APPEAL SUMMARY

| Appeal ID: 33407 | Project Address: 3950 N Williams |
| Building/Business Name: Kiley40 | Fire Sprinklers: Yes - Whole building |
| Appeal Involves: Erection of a new structure, Reconsideration of appeal | LUR or Permit Application No.: 24-029720-CO |

D. STAIR DETAIL

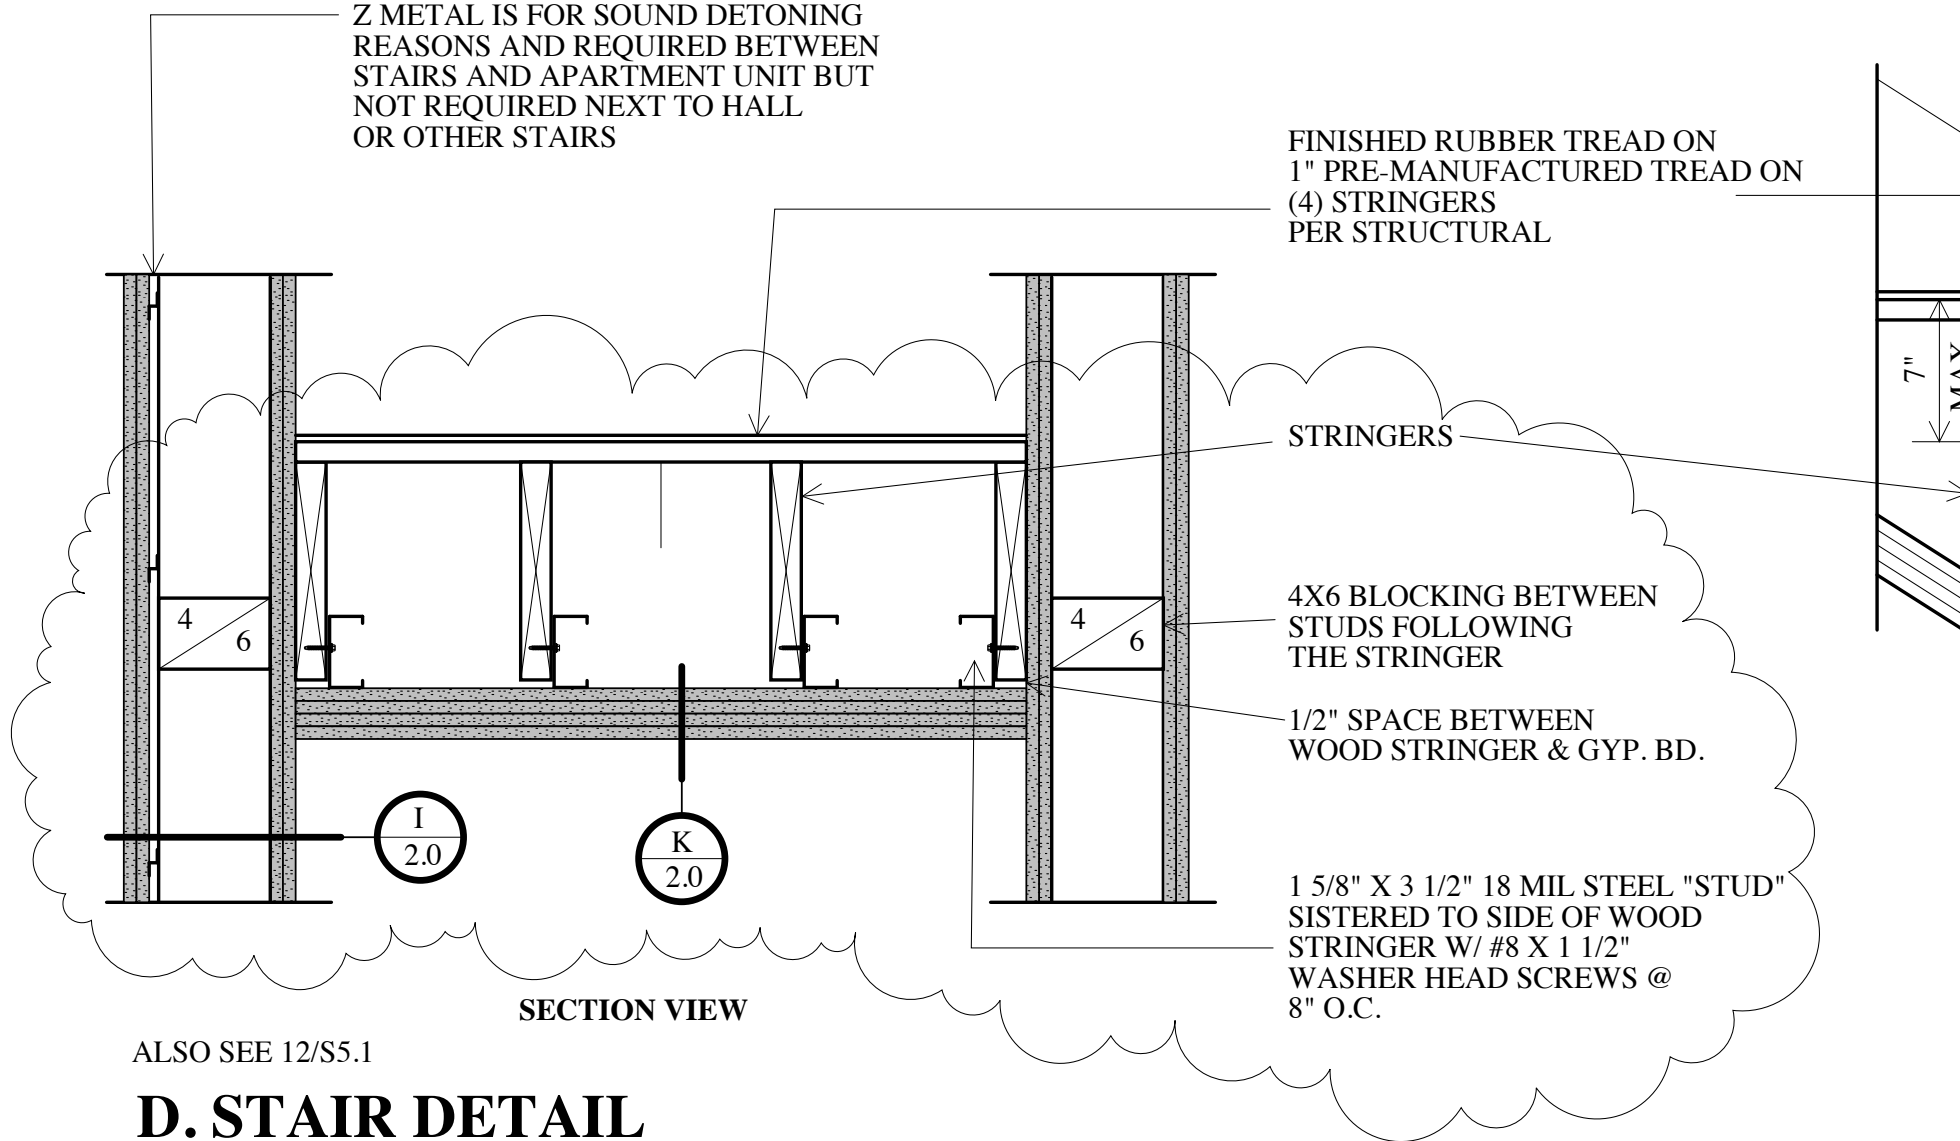
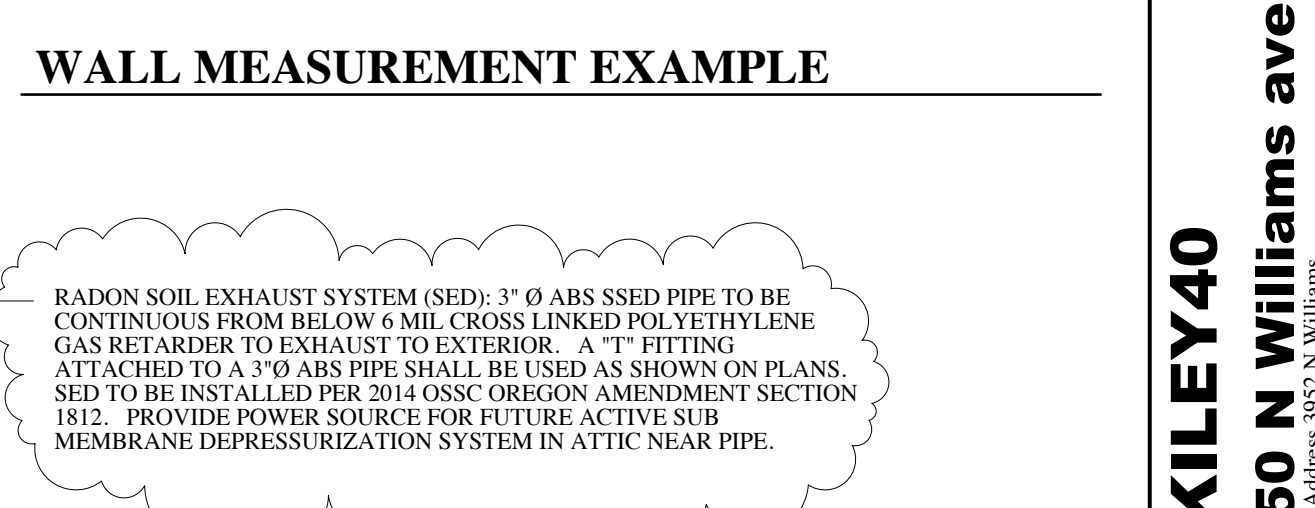
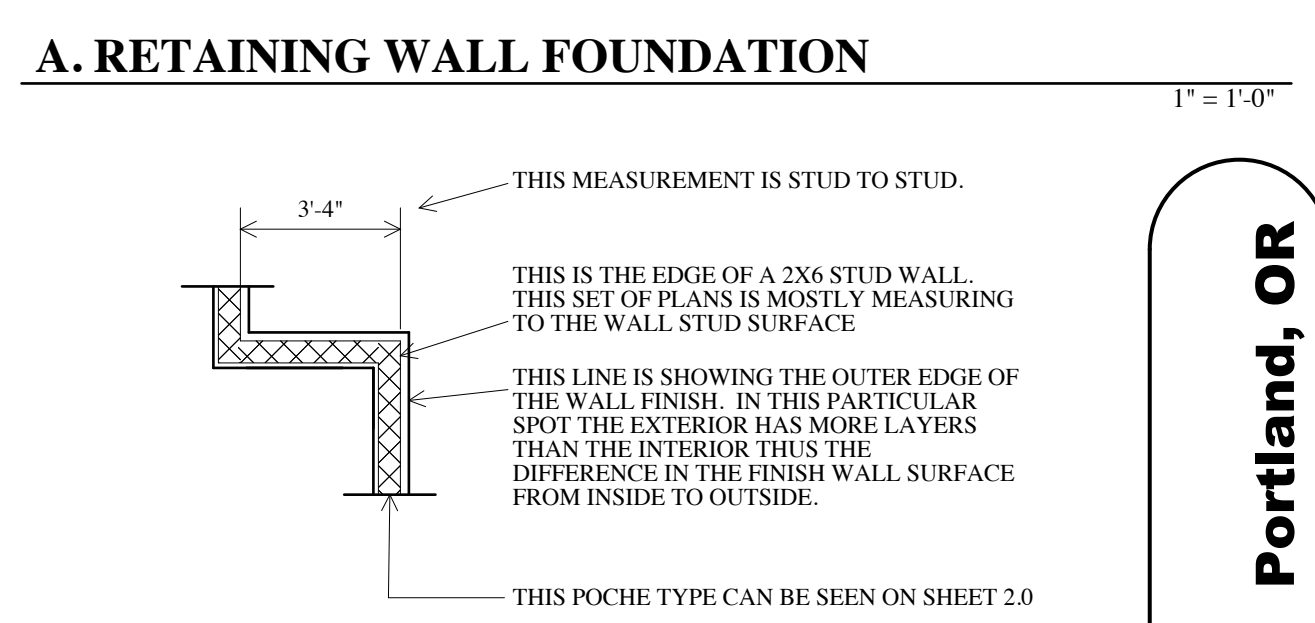
| Proposed Design | <p>Original appeal:</p> <p>I will be using a 2-hour shaft assembly GA file #WP 7125 as the 2-hour assembly under a wood framed staircase to separate one stairway from another. You can see my stair section and details on attached sheet 8.1 and the assembly at detail K/2.0</p> <p>Reconsideration:</p> <p>Using the same 2-hour shaft assembly in the original appeal and adding the steel "studs" to the sides of the wood stringers to complete the 2-hour fire rating as specifically stated in the fire resistance design manual.</p> |

In the original appeal there was concern for using wood stringers to attach the gyp bd to when the listed assembly was referring to using steel studs. So to completely comply to the listing I am adding the steel studs to the assembly.

1 5/8" X 3 1/2" 18 MIL STEEL "STUD"
SISTERED TO SIDE OF WOOD
STRINGER W/ #8 X 1 1/2"
WASHER HEAD SCREWS @
8" O.C.

- "1) Increase of allowable wall opening percentage from 45% to 62% on the first floor of the east side: Granted provided the fire rating of the floor-ceiling assembly above the patio is increased to a 2-hour fire-resistance rating.**
- 2) Alternate method for determining fire resistance rating of 2-hour shaft wall assembly: Granted structural engineering calculations for connecting and supporting the gypsum board layers in this incline orientation are provided and approved during plan review.**
- 3) Continuation of interior exit stair to exit discharge with exit passageway: Exit discharge from an exit stair through an exit passageway meets the 1023.3 Exception and does not require a building code appeal. However, the current configuration does not meet the requirements for exit passageways (for example: 1024.5 Openings). "**
